Addendum #3

Date: July 2, 2015
Project: Campus Lighting Improvement
Contract: FD-15-013

R E V I S I O N S						PROJECT TITLE: CAMPUS LIGHTING IMPROVEMENTS					
REV.	REVISIONS	RVSD	CHCKD	APRVD	DATE	PARTIAL SITE PLANS – PARKING LOT LIGHTING–P1, P3, P4, P16, P18, P19, P25					
1	REVISED PER ADDENDUM #3 - 7/2/2015					SCALE		AS NOTED	DATE	REVISION NO.	0
						DRAWN BY		EML	05/08/15	E–101	
						CHECKED BY		DEDC	05/18/15		
						APPROVED BY		DEDC	05/18/15

3 LIGHTING PLAN – LOTS P-18 & 28
E101 SCALE: 1/64"=1'-0"

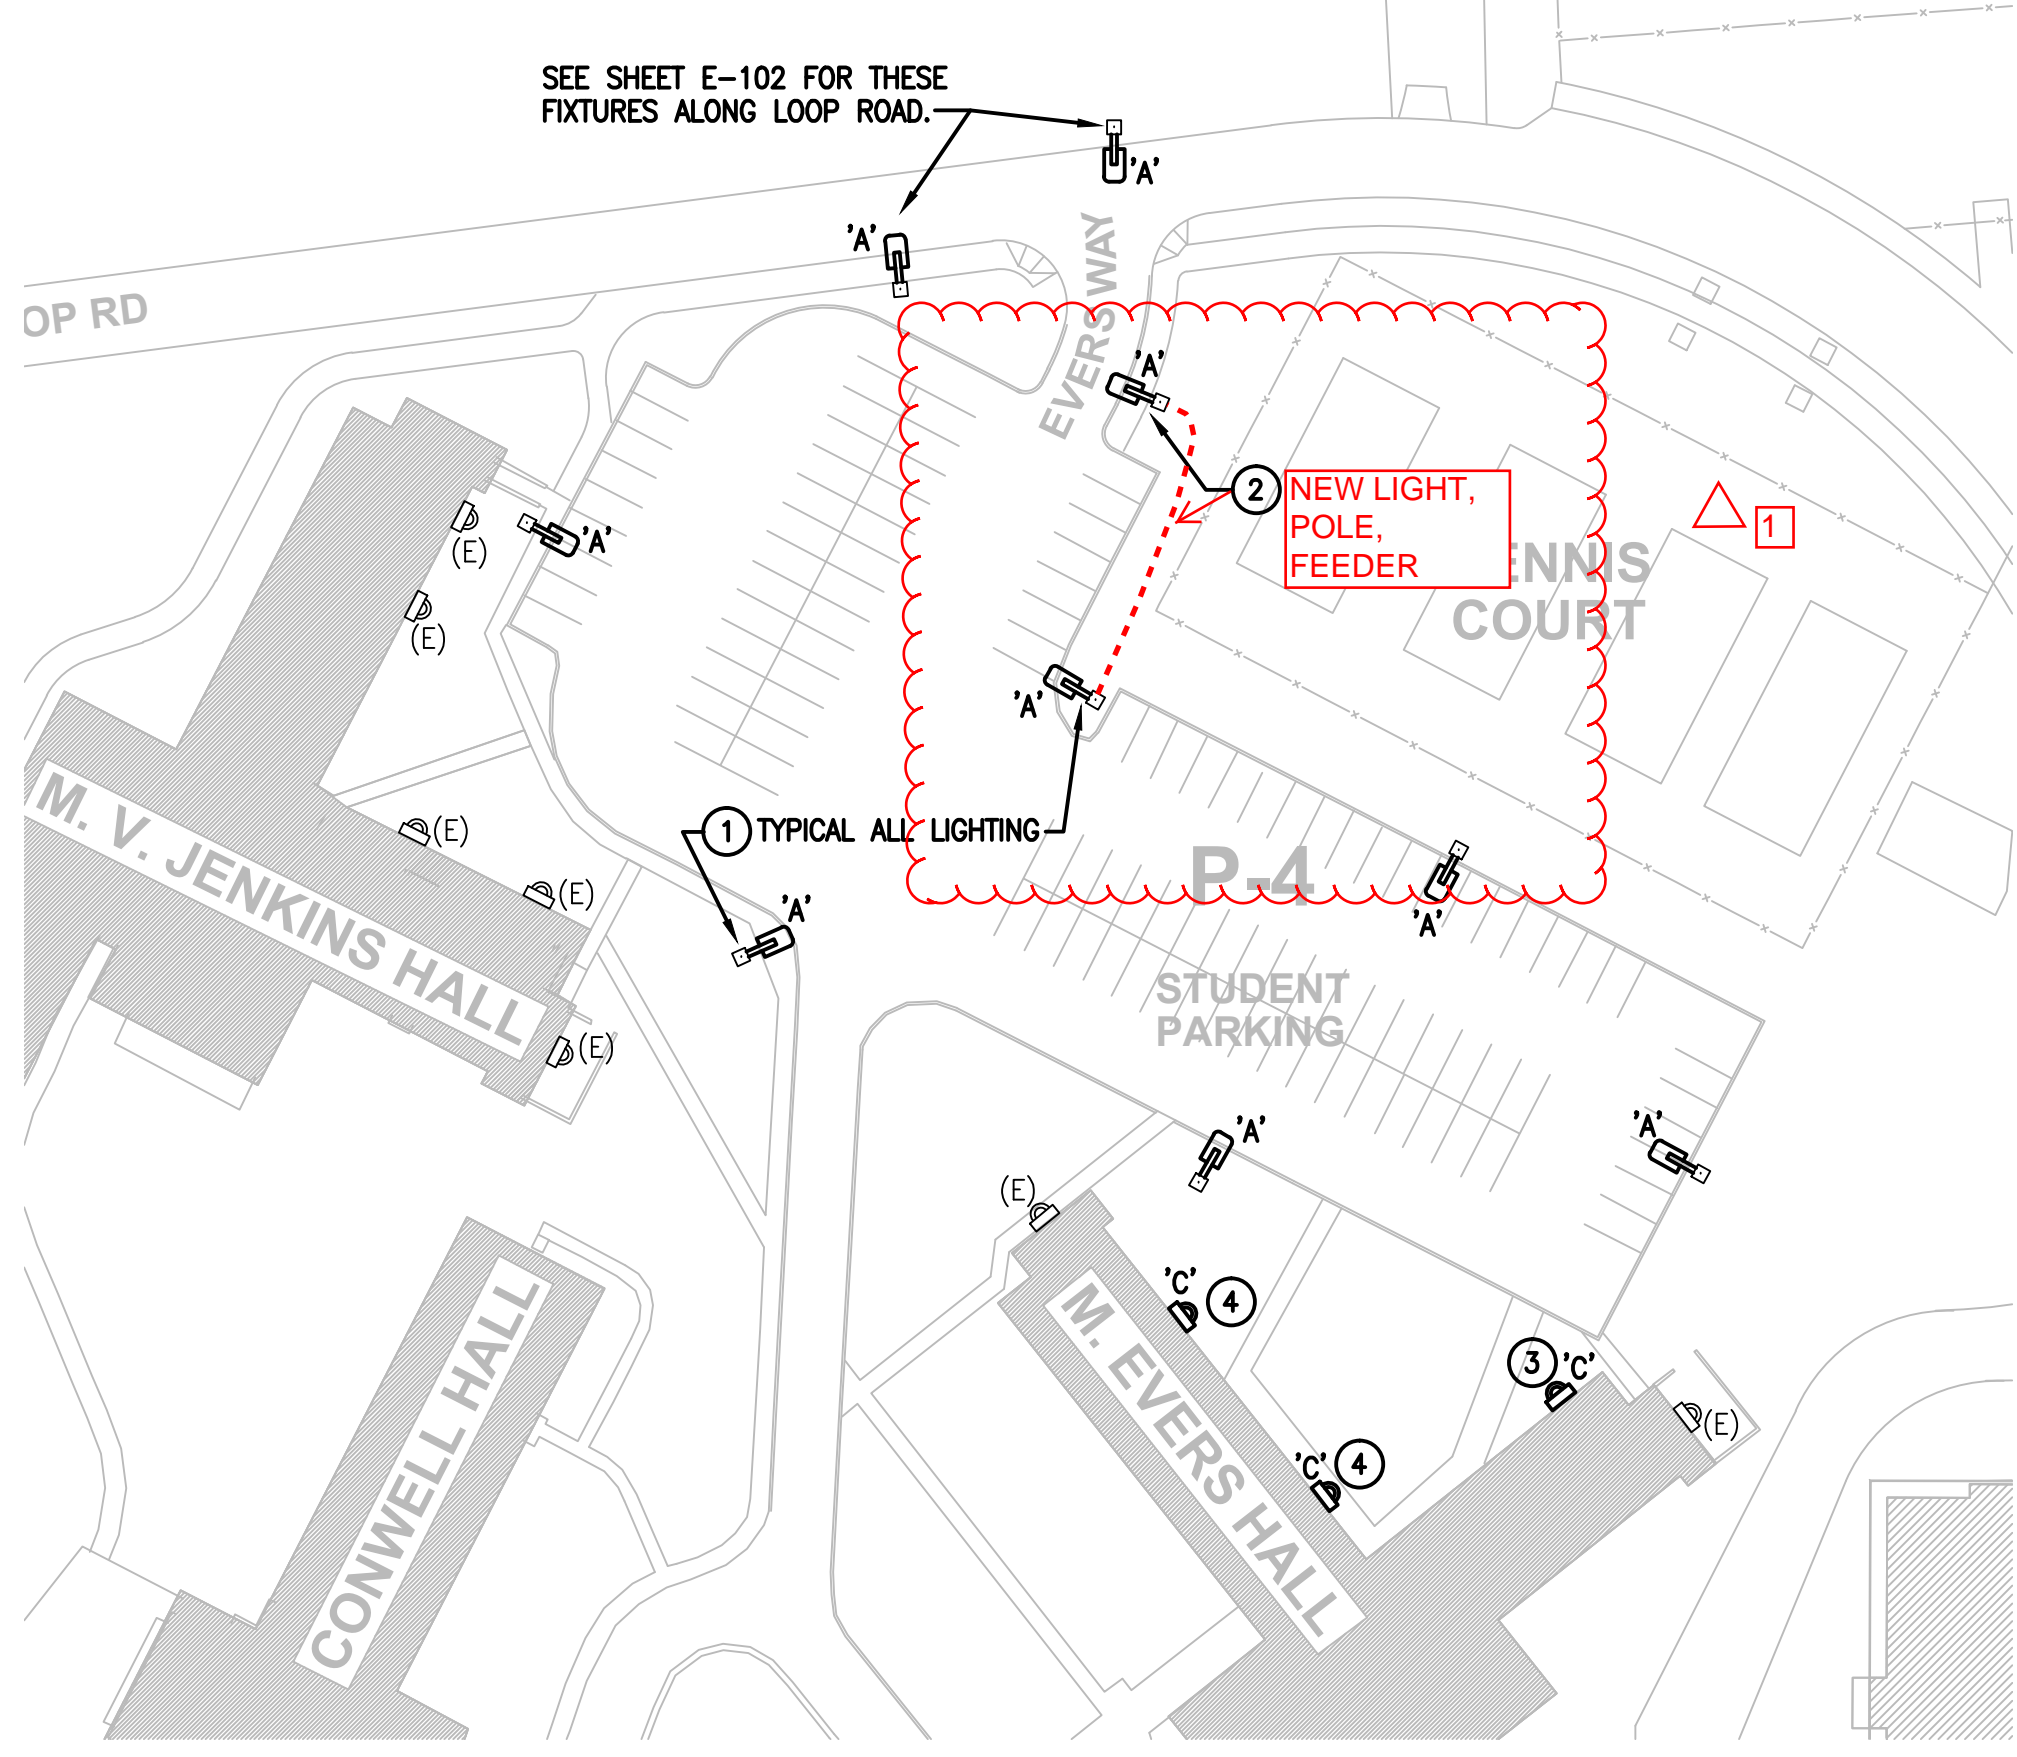
1. Drawing E-101 – Drawing has been reissued to clarify scope based on contractor questions.

Question: Drawing E101 at M.Evers Hall shows two new wall packs to use the existing circuit. Can the new conduit be surface mount on the outside of the building? If not will it have to ran inside the building are there drop ceiling for route for the new wiring?

Question: At the tennis court are they show a new type fixture and pole. Need location where it be will fed from.

Answer: The new conduit can be surface mounted to the outside of the building. Conduit shall be galvanized rigid metal conduit, properly supported, and adequately fastened to the existing building construction.

Answer: Refer to attached drawing E-101 for source and diagrammatic conduit path. Install in accordance with detail 5/E-201.
